STAFF REPORT

APPLICATION PRC 80-C-111

PRC PLAN PROPOSAL: PRC Plan approval to permit expansion of the existing church parking lot

CHURCH OF LATTER DAY SAINTS - RESTON
PARKING LOT EXPANSION
PRC PLAN AMENDMENT

EXISTING VEGETATION MAP - SUMMARY TABLE

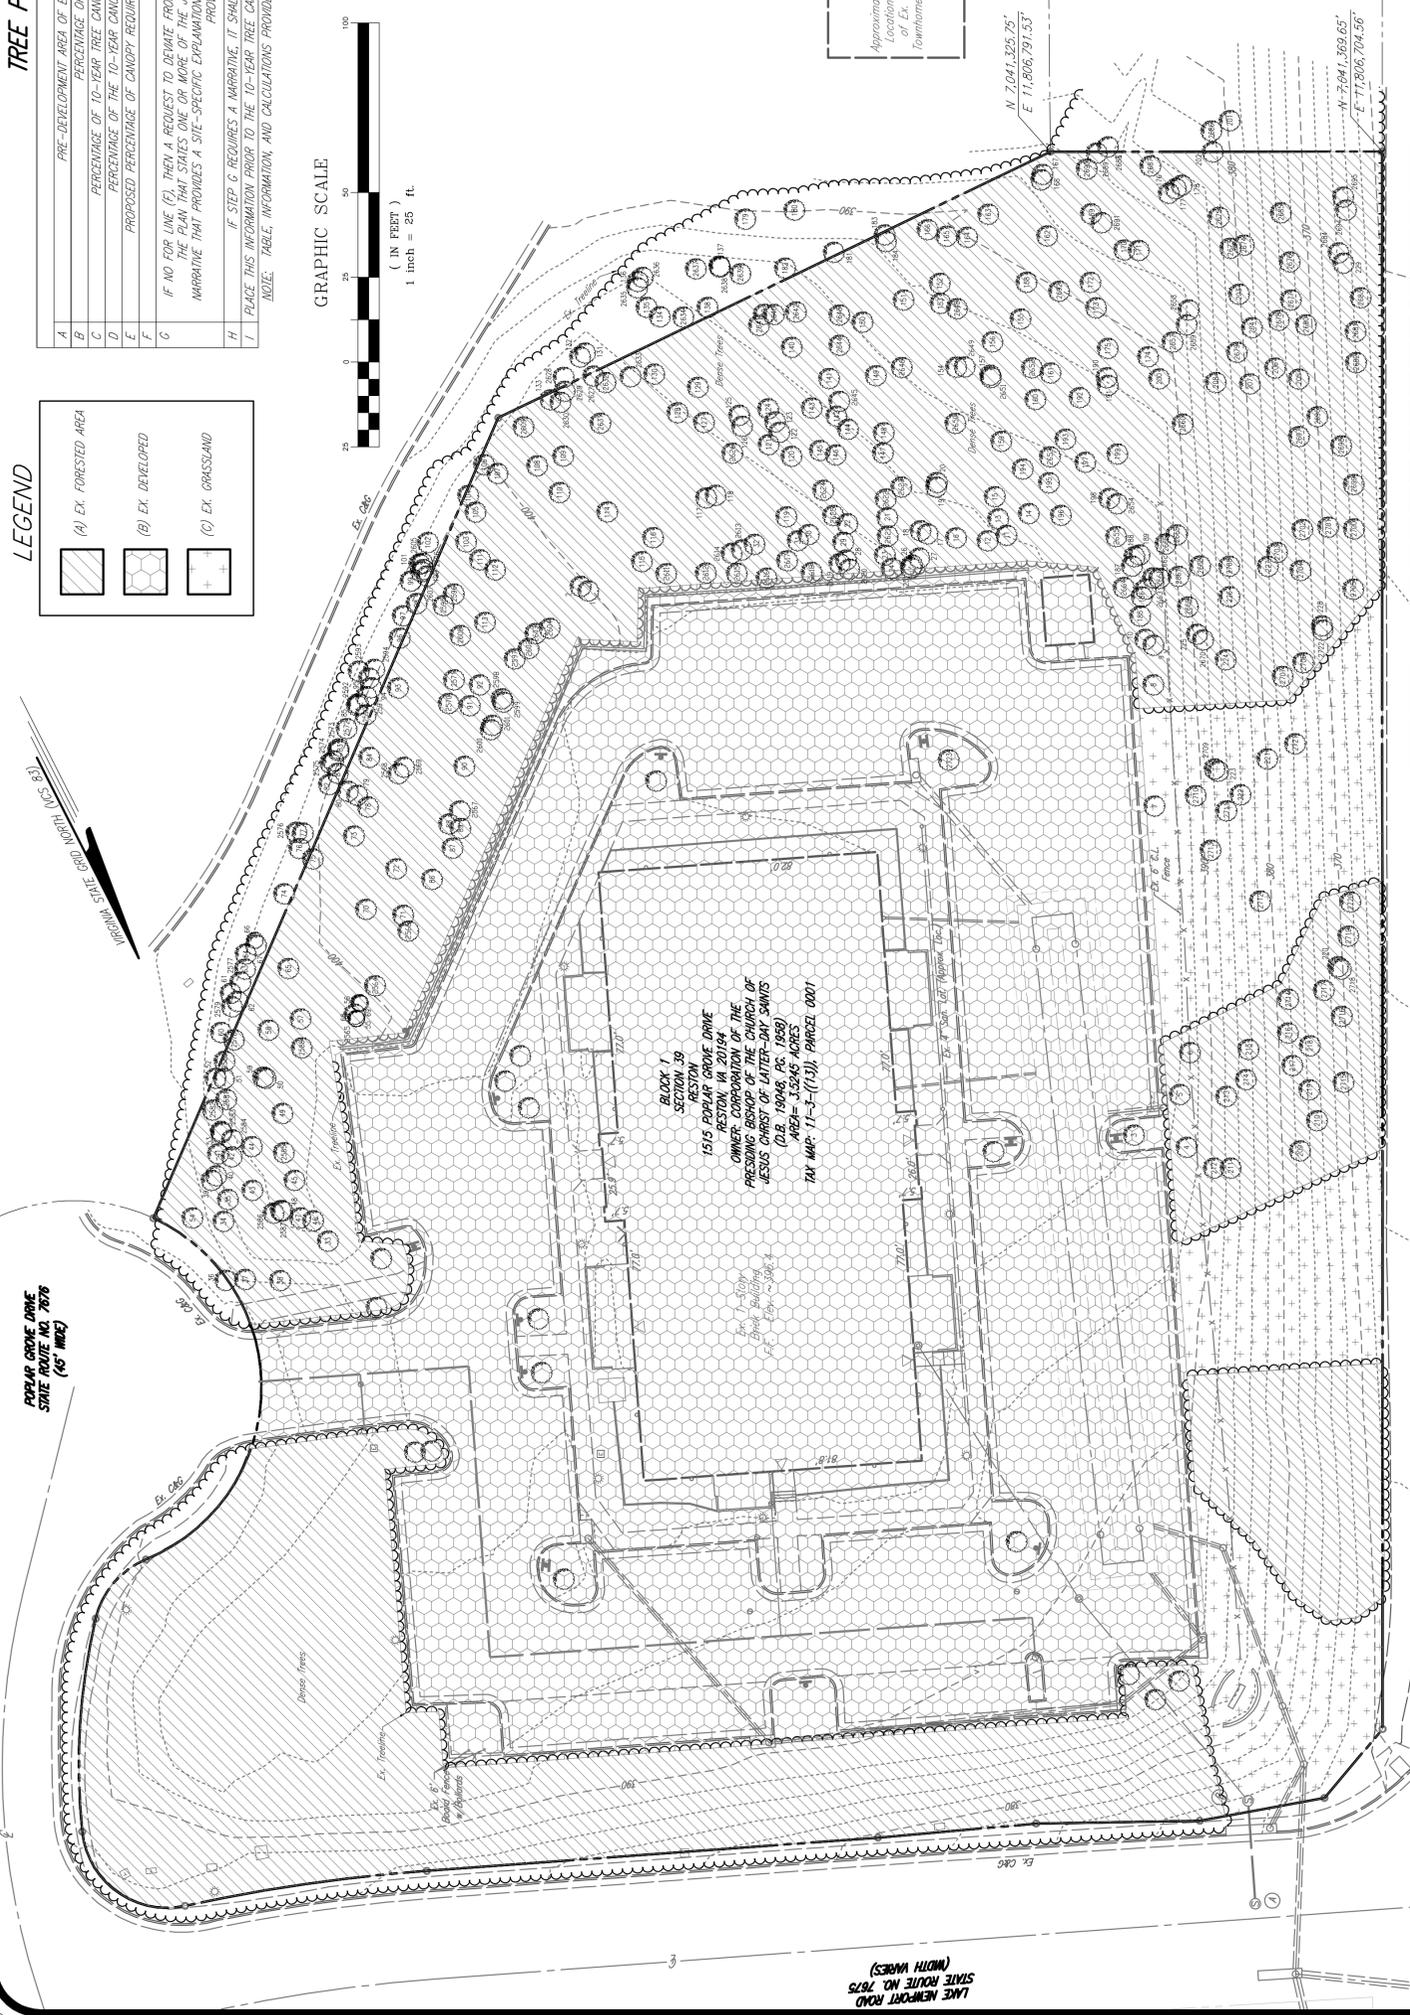
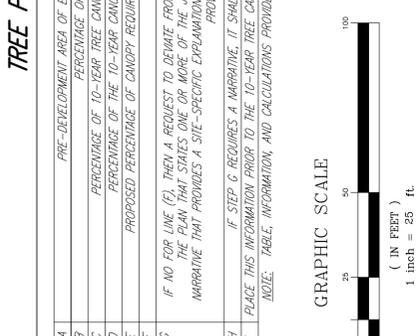
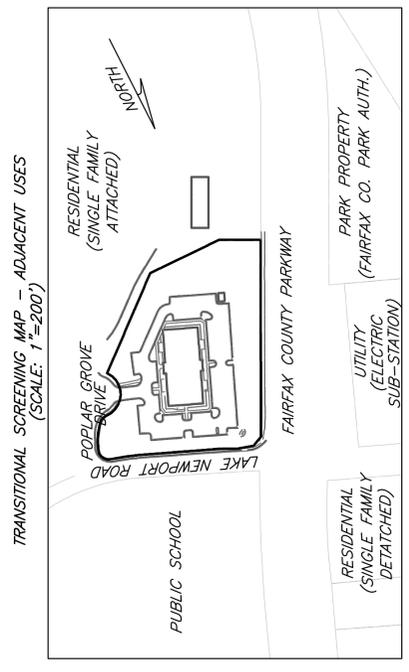
3. **Comment:** It is unclear how the area indicated for the Tree Preservation Target was calculated. The Tree Preservation Target is the product of the area of the 10-yr. tree canopy required (Line B7 of PFM Table 12.10) x the percentage of the gross site area covered by existing tree canopy (Line B of PFM Table 12.3).

WATERSHED MAP (SCALE: 1"=30')

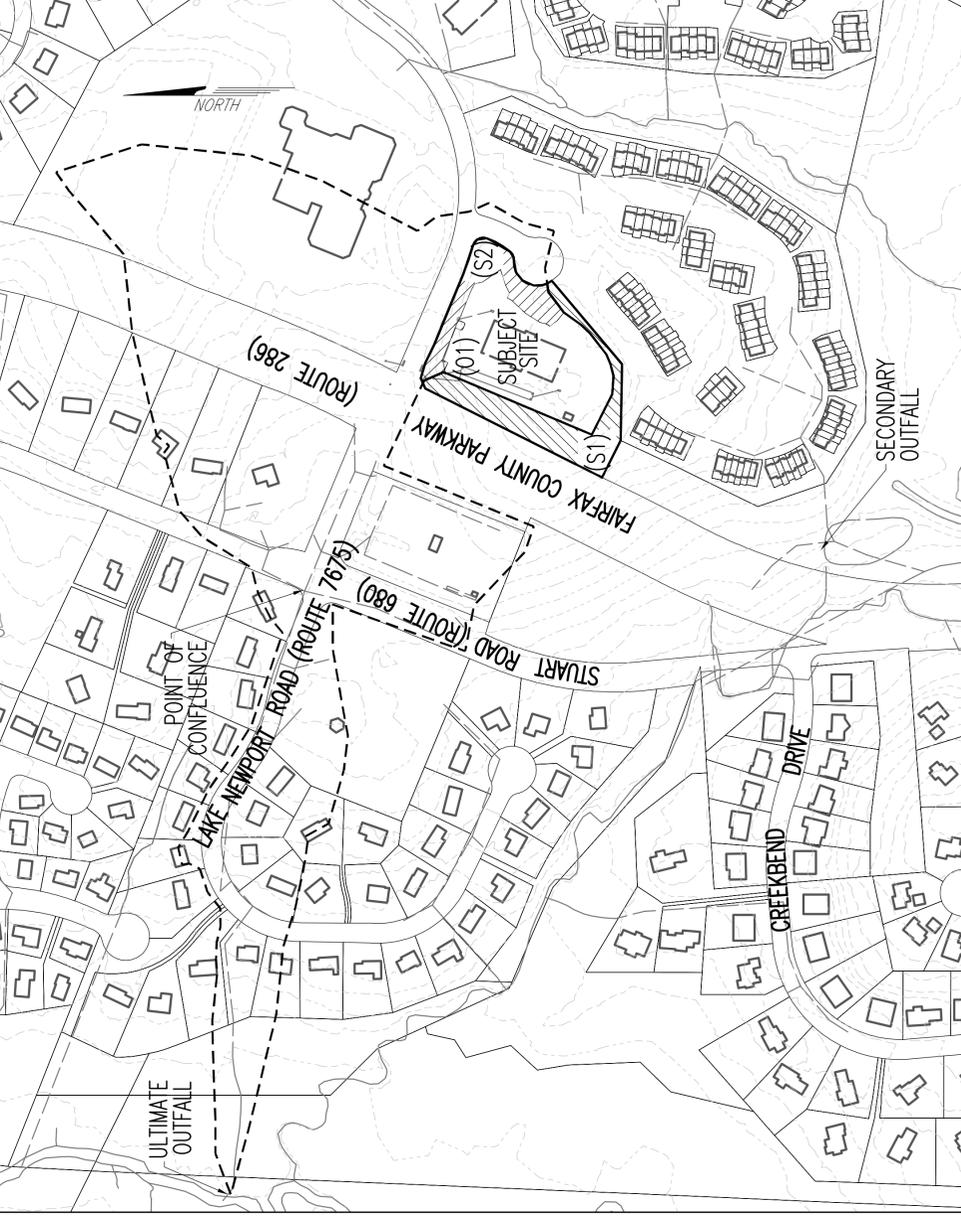
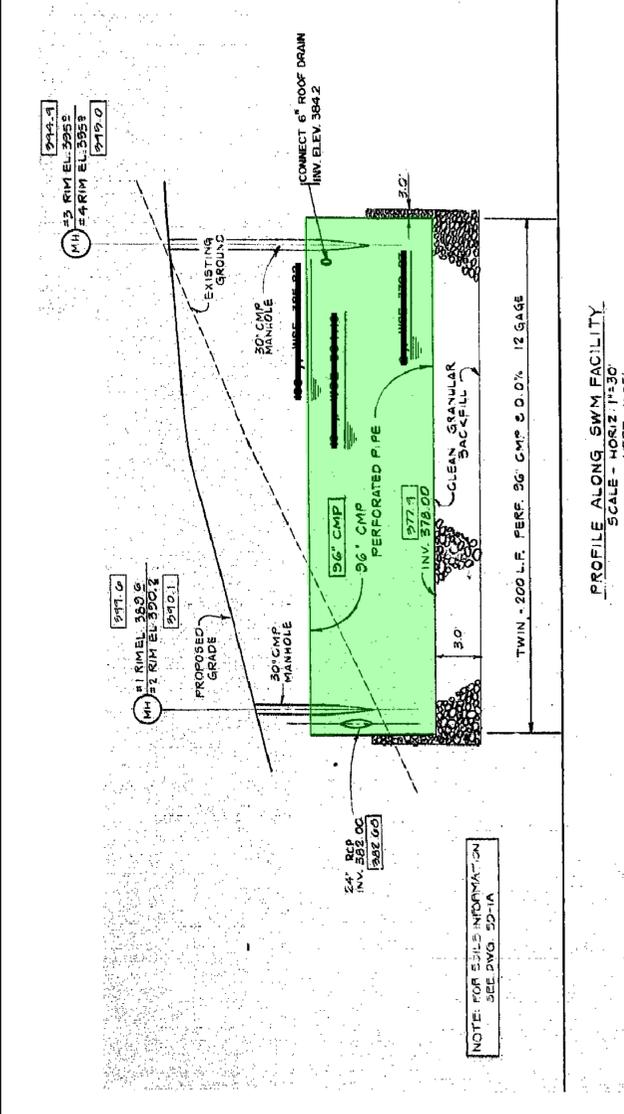
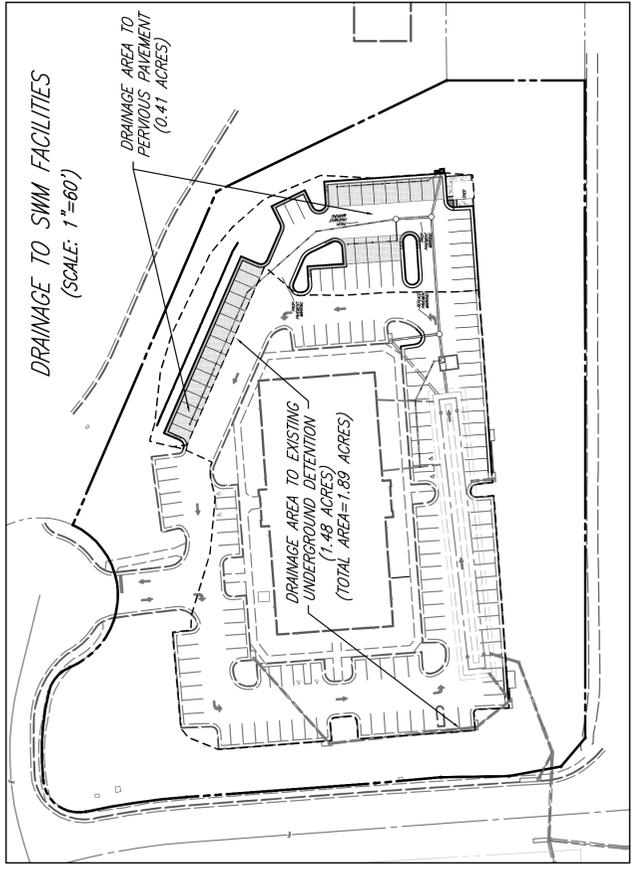
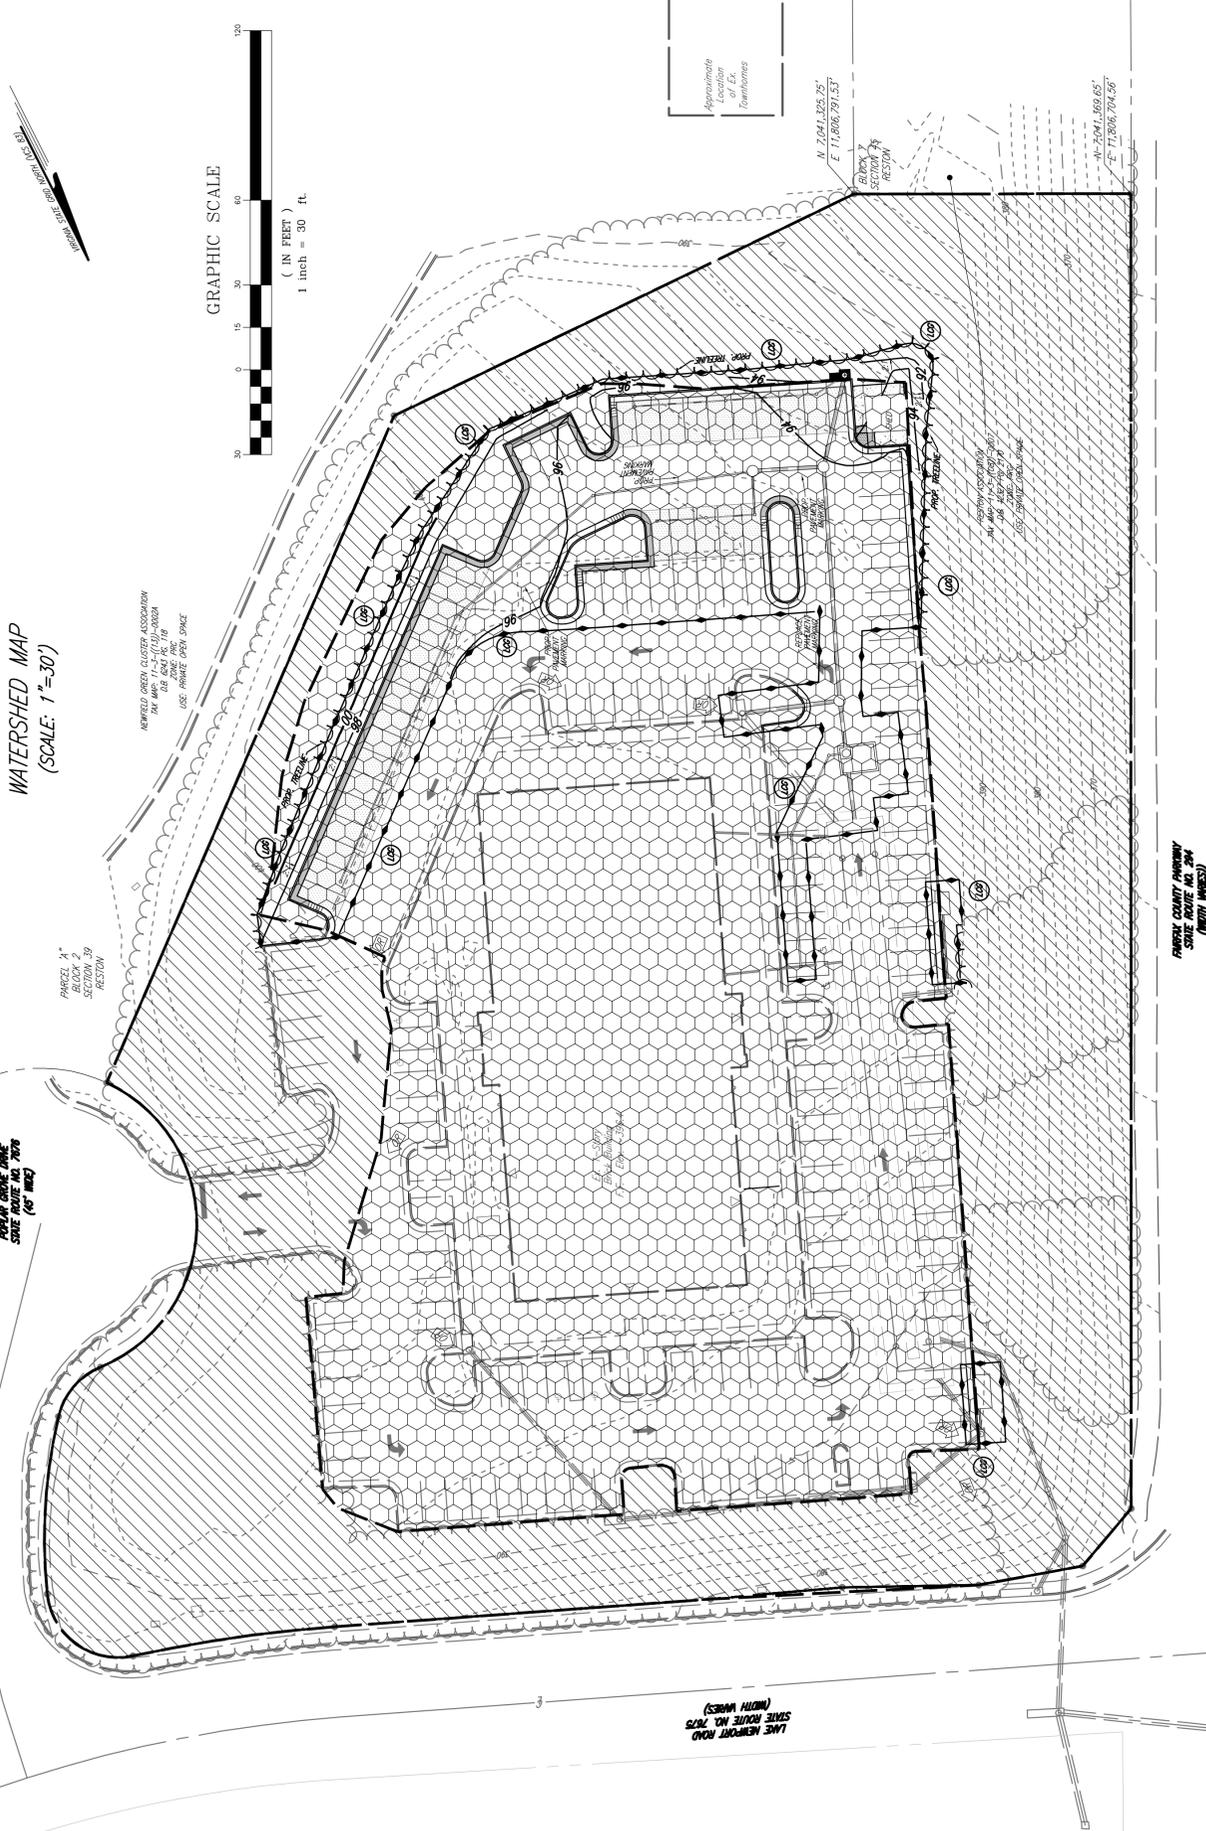
The plan indicates that the existing underground detention facility will be utilized to meet the detention requirements. Runoff routing through the facility and hydrologic and hydraulic computations will be reviewed during site plan review.

The applicant has provided a narrative and a summary of computations to demonstrate how the concentrated stormwater flow will be released into a stormwater conveyance system. The details of the hydrological and hydraulic computations will be reviewed during site plan/sub division plan review.

An outfall narrative has been provided, however, the description of the adequacy and stability of the outfall is not a part of the statement. Adequate outfall analysis will be reviewed during the site plan review.
